**RE: 3308 4<sup>th</sup> Street Apartment Building**  
**Grading and Drainage Plan**  
**Engineer's Stamp Date: 04/30/18**  
**Hydrology File: H14D109**

Based upon the information provided in your submittal received 05/04/18, the Grading and Drainage Plan **is not** approved for Building Permit, Grading Permit, and SO-19 Permit. The following comments need to be addressed for approval of the above referenced project:

3308 4th SREET NW  
GRADING AND DRAINAGE PLAN

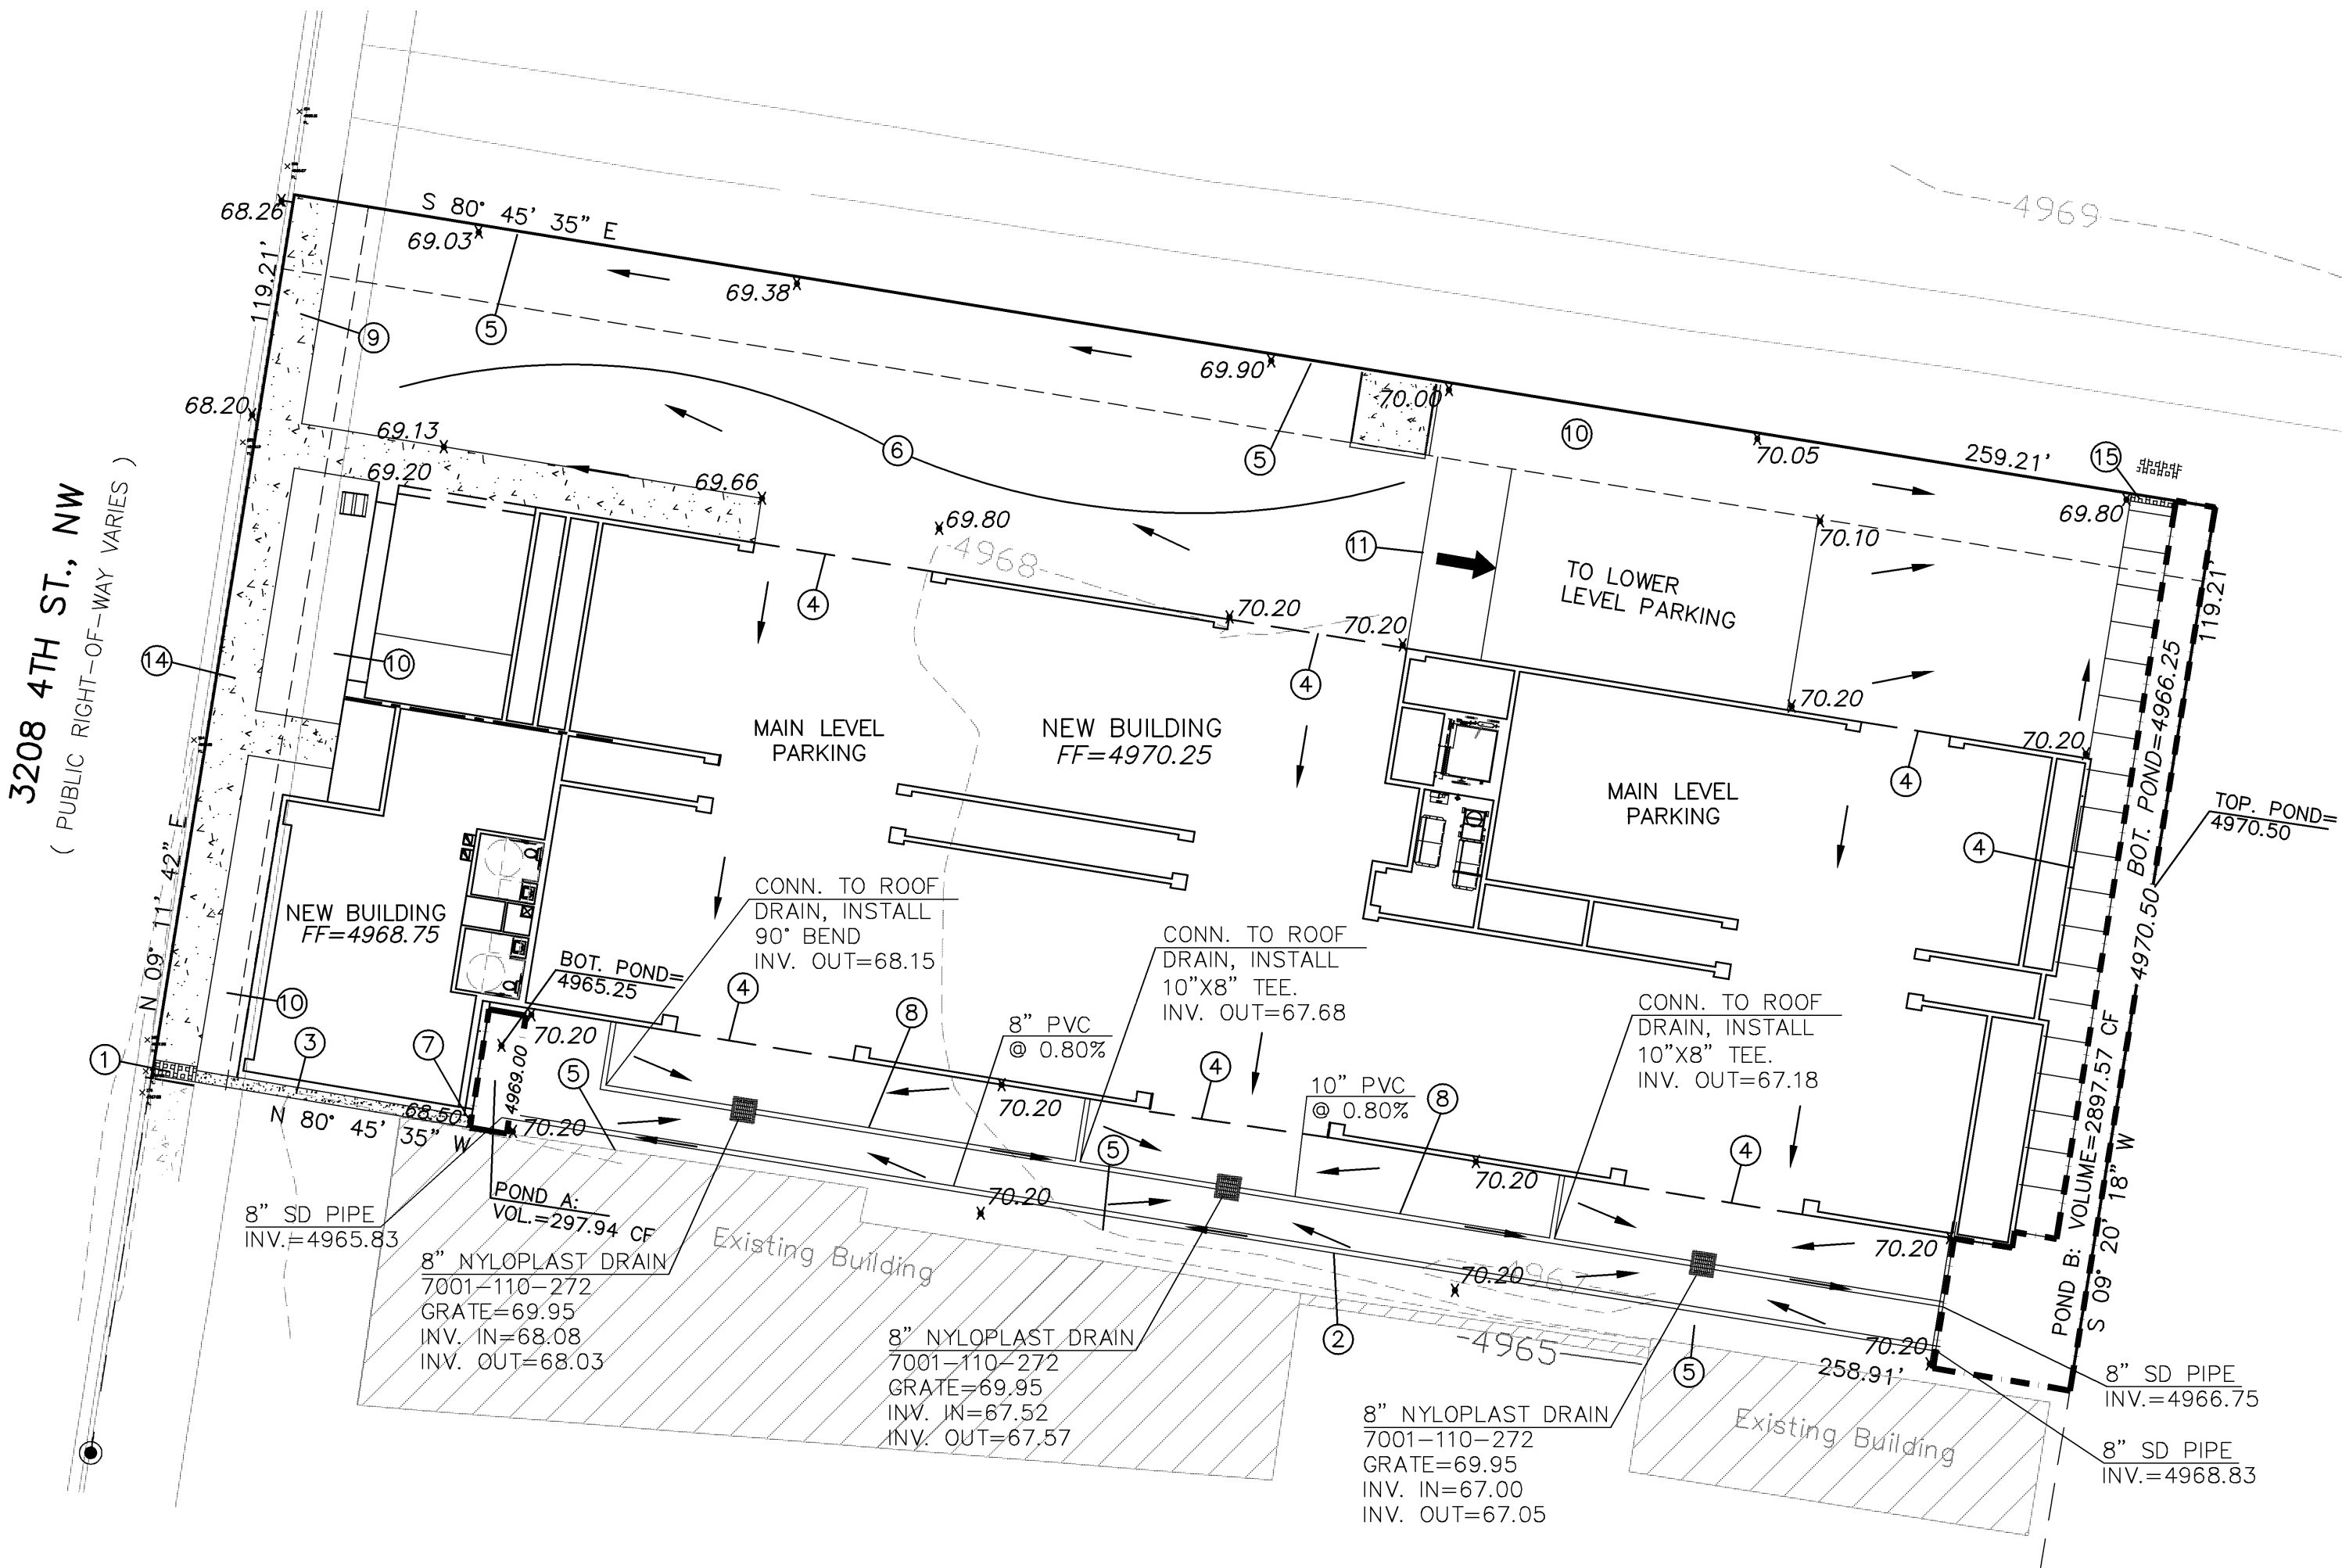
1. Please provide the weir calculations for the sidewalk culverts and 18" opening in Pond A.

2. Please provide calculations for the 18" concrete channel.

3. Please provide invert elevations for the 18" opening in Pond A, 18" concrete channel, and both side walk culverts.

4. Please provide a section for both Pond A & B depicting the first flush volume elevation, 100 detention WSE, and the required freeboard.

5. How is Pond B outfalling? It appears to have no outfall, therefore it is a retention pond. As such, please provide the 100 year – 10 day calculations.
